May 09, 2013

RE: Gallatin County Alternative School & Field House
Gallatin County, Kentucky
BG 12-133
RTA 0914

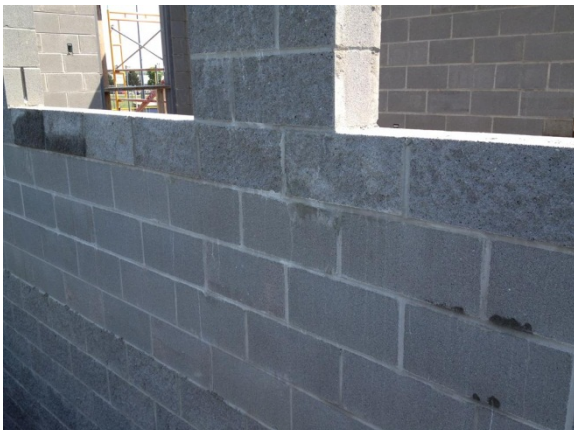
2. Trenching for horizontal connection to geo thermal wells is under way.
